Access Compliance Report Public Rights-of-Way (Curb Ramps)

Main Street: PETERS_AVE Cross Street: MONROE_ST Location: SE

ADA ID: RPRK210930131753 Ramp Type: Type 1 - Perpendicular Diagonal Initial Pass/Fail: Fail Overall Compliance: No Severity Score: 15

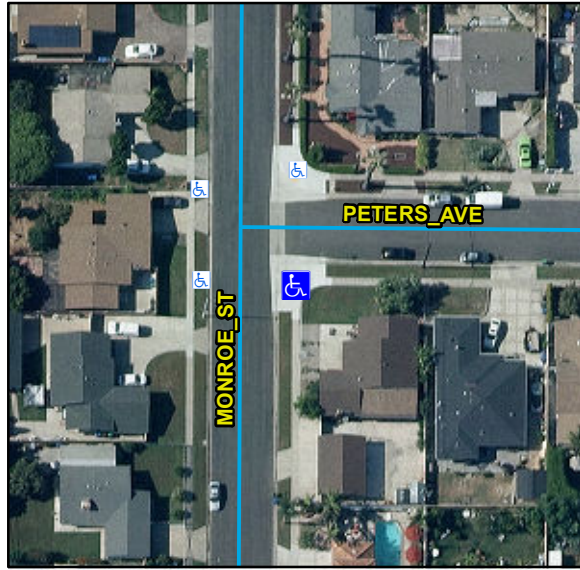
Compliance	Description	Data	Compliance	Description	Data
N/A	Ramp Length (in)	134	N/A	Flare Type LT	
Yes	Ramp Width (in)	48			N/A
No	Ramp Run Slope (%)	10.5	N/A	Flare Slope LT (%)	N/A
Yes	Ramp Cross Slope (%)	0.3	N/A	Flare Traversable LT	N/A
N/A	Landing Present	N/A	N/A	Flare Type RT	
N/A	Landing Length (in)	N/A			N/A
N/A	Landing Width (in)	N/A	N/A	Flare Slope RT (%)	N/A
N/A	Landing Run Slope (%)	N/A	N/A	Flare Traversable RT	N/A
N/A	Landing Cross Slope (%)	N/A	N/A	DWS Provided	N/A
N/A	Landing Movement Obstructed?	N/A	N/A	DWS Contrast	N/A
	Landing Movement Type	N/A	N/A	DWS Length (in)	N/A
N/A	Landing Shared	N/A	N/A	DWS Full Width	N/A
N/A	Clear Space	Yes	N/A	DWS Offset Left (in)	N/A
N/A	Clear Space To Crosswalk (in)	N/A	N/A	DWS Offset Right (in)	N/A
N/A	Marked Crosswalk 1	No	N/A	Marked Crosswalk 2	No
	Crossing 1 Direction	N		Crossing 2 Direction	W
	Marked Crosswalk 1 Width (in)	N/A		Marked Crosswalk 2 Width (in)	N/A

Remove & Replace Curb Ramp With Two New Directional Ramps or Equivalent.
